<b>Project Title:</b>	<b>Addendum No.:</b>
Stanley Knowles Fit-Up	2
<b>Project Location:</b>	<b>Project Number:</b>
391 York Avenue Winnipeg, MB	R.056754.002
<b>Consultant's Name</b>	<b>Date:</b>
Prairie Architects Inc.	January 15, 2014

**The following changes in the bid documents are effective immediately. The addendum will form part of the contract documents**

**MR-08**

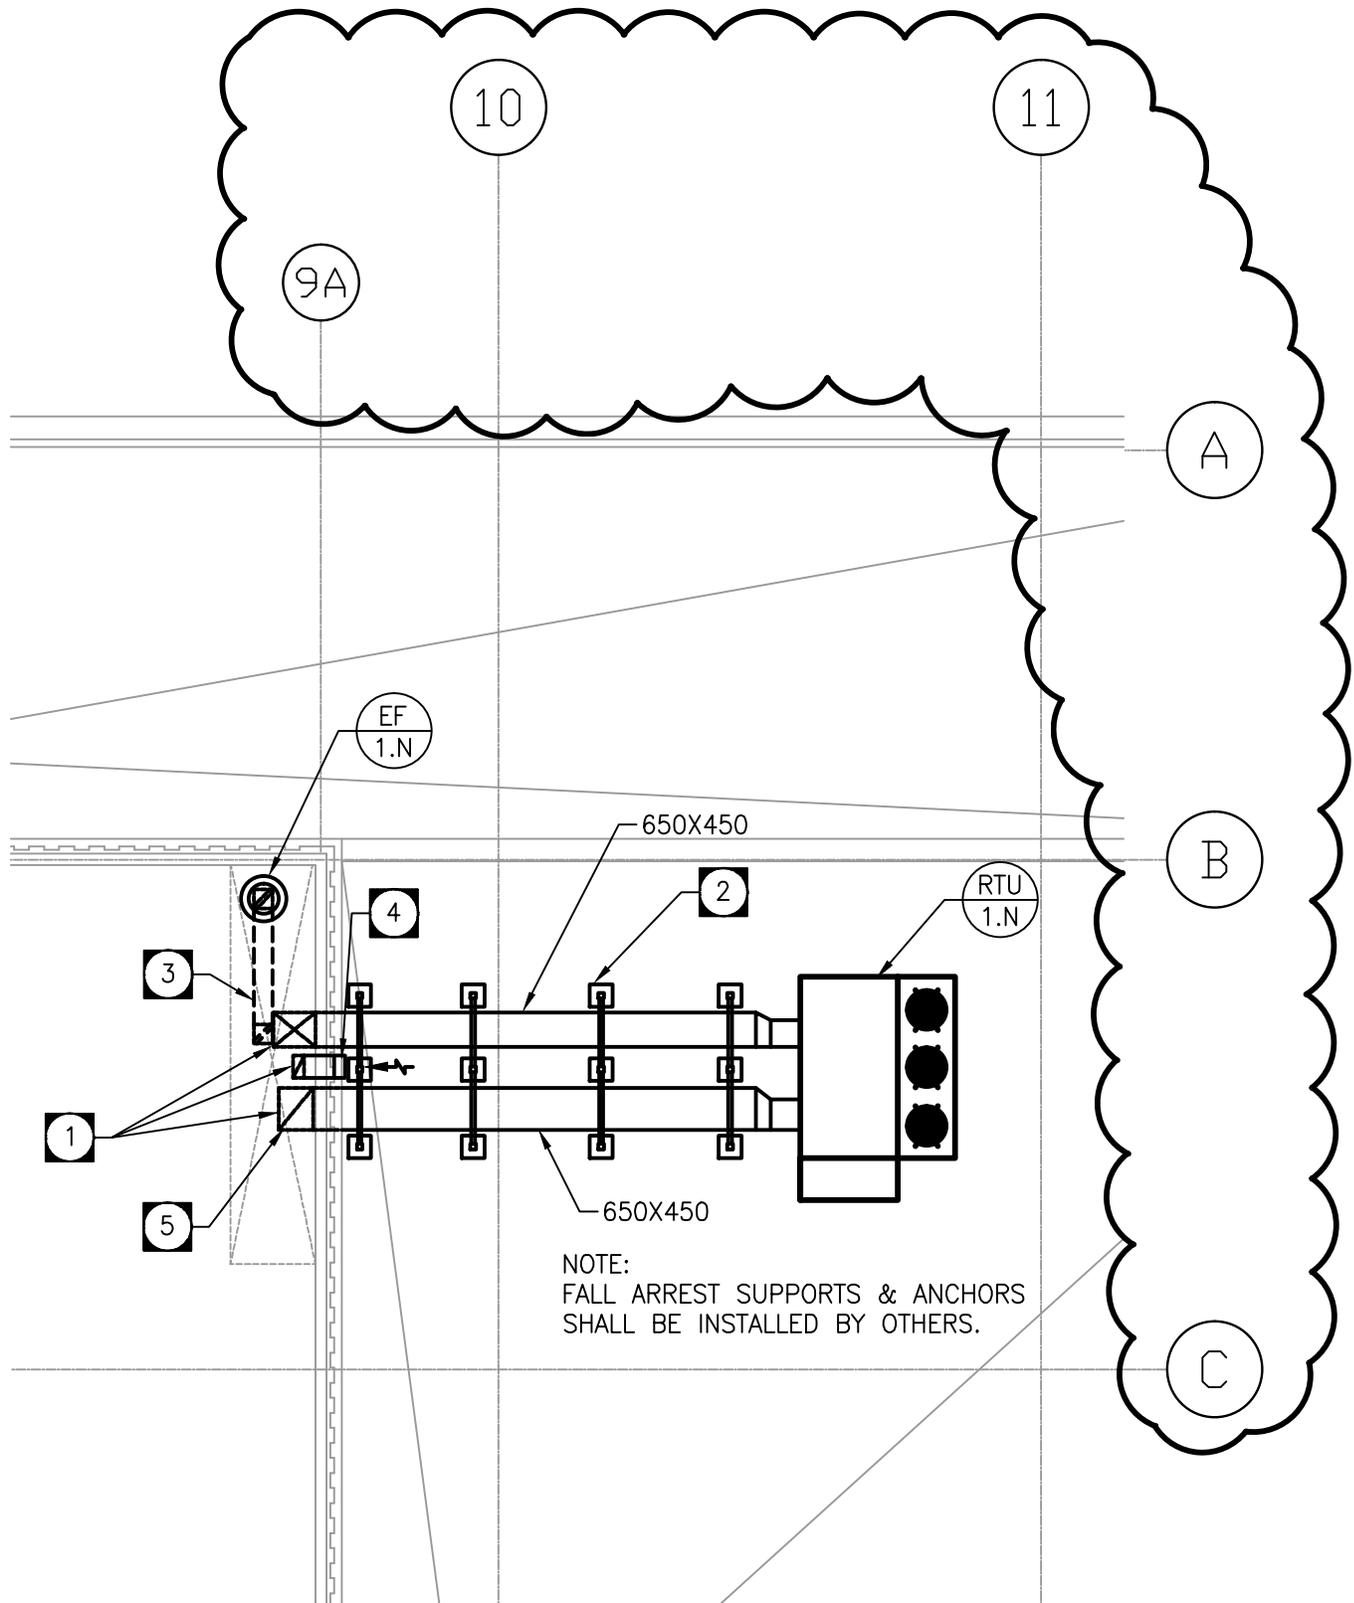
- .2 Provided locations of new fire dampers through fire rated separations and non-rated fire separations indicated on Architectural drawing A2-02. Refer to Architectural drawing A2-02 for all rated and non-rated fire separation locations. Refer to attached Mechanical Revision sheet **MR-07 & MR-08**.

**MR-09**

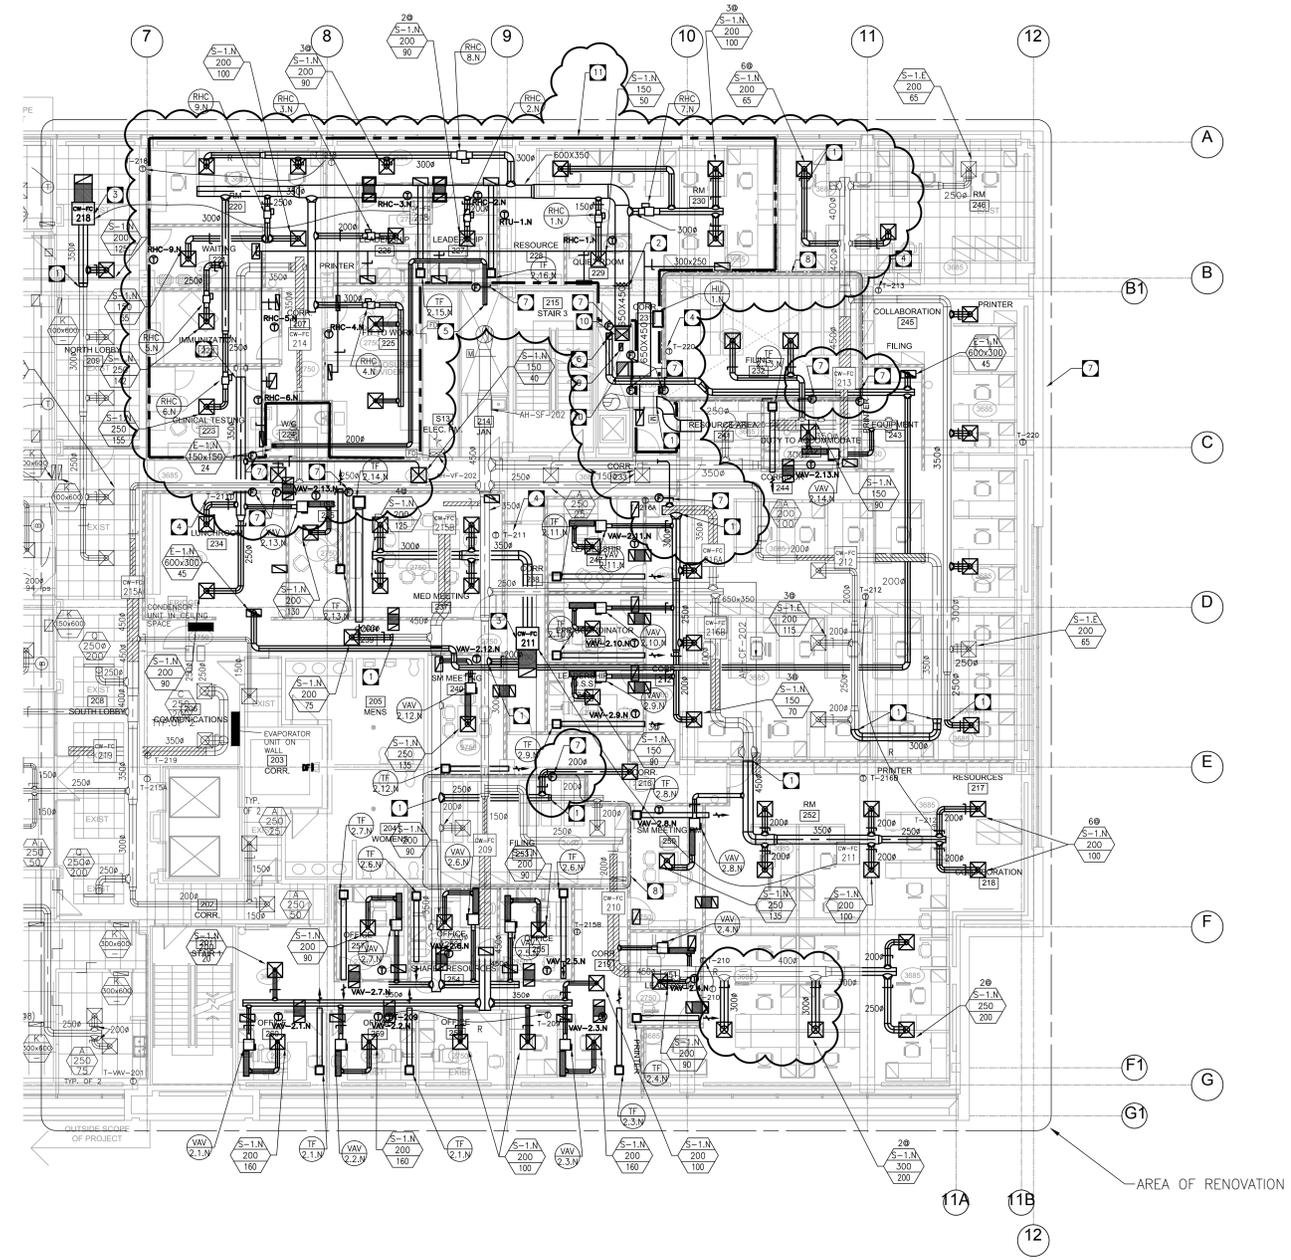
- 1.7 Drawing M2-06 Mechanical – Roof Plan and Details – New HVAC
  - .1 Added gridline numbers to “Roof Plan”. Refer to attached Mechanical Revision sheet **MR-09**.

Project No./No. du projet: <b>R.056754.002</b>	Sheet / Feuille: <b>M2-05</b>	Revision no. / La Révision no.: <b>0</b>
--	-------------------------------	--

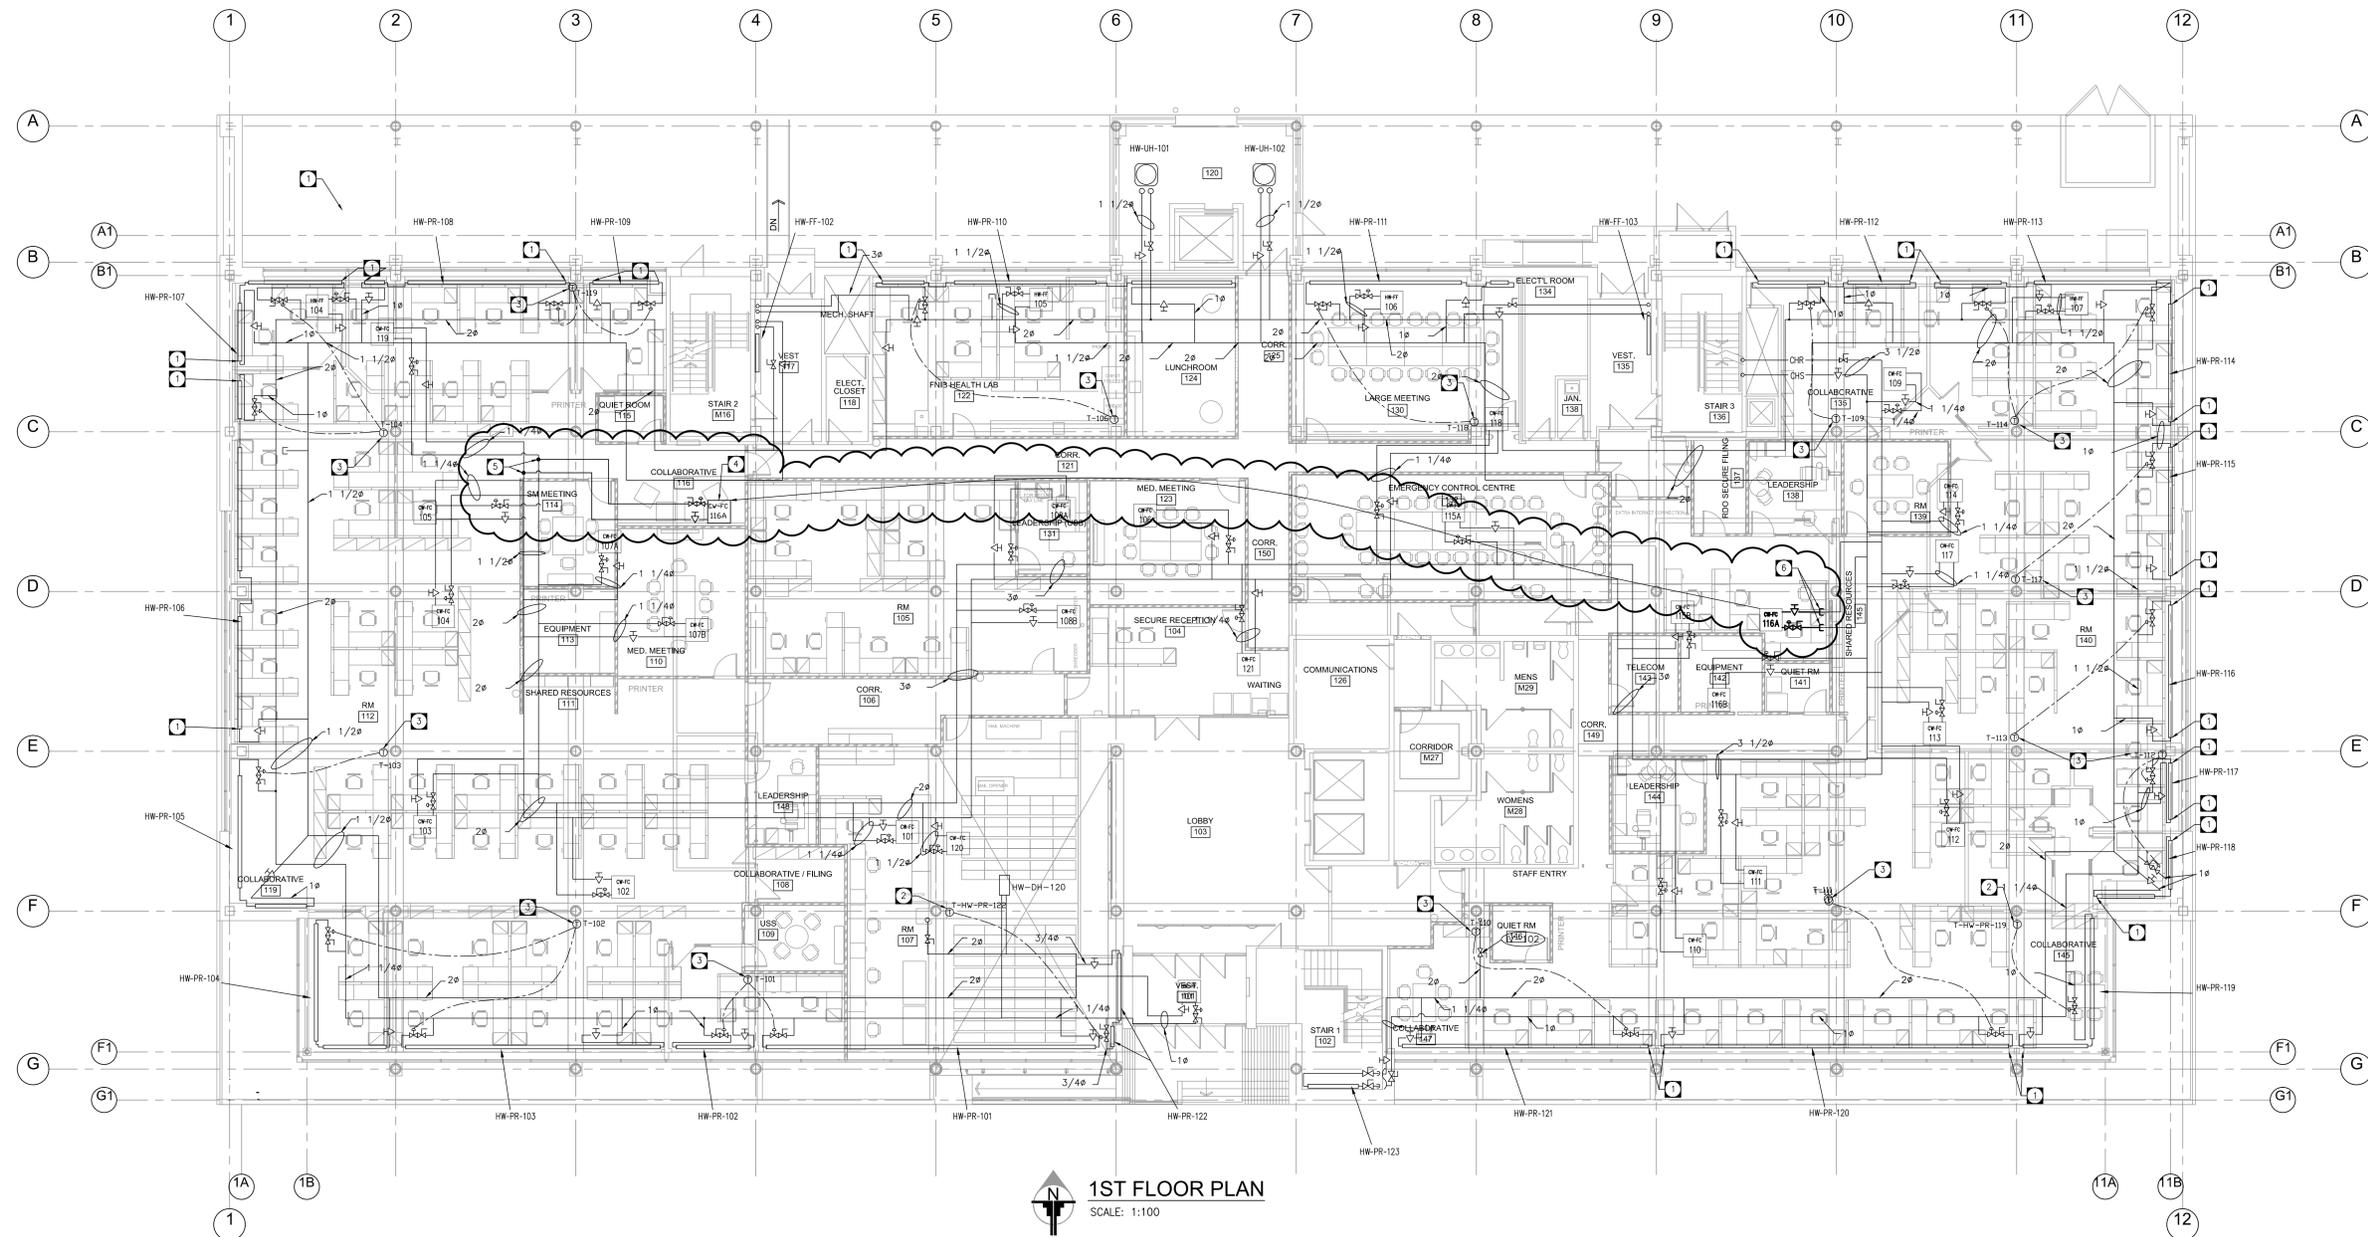
- 1.6 Drawing M2-05 Mechanical – Partial 2nd Floor Plan – New HVAC
  - .1 Provided locations of new fire dampers through fire rated separations and non-rated fire separations indicated on Architectural drawing A2-05. Refer to Architectural drawing A2-05 for all rated and non-rated fire separation locations.

- .2 Added Drawing Note #11 and indicated area of application.
  - .3 Added Additional new ductwork to be completed.
  - .4 Refer to attached full size drawing **M2-05**.
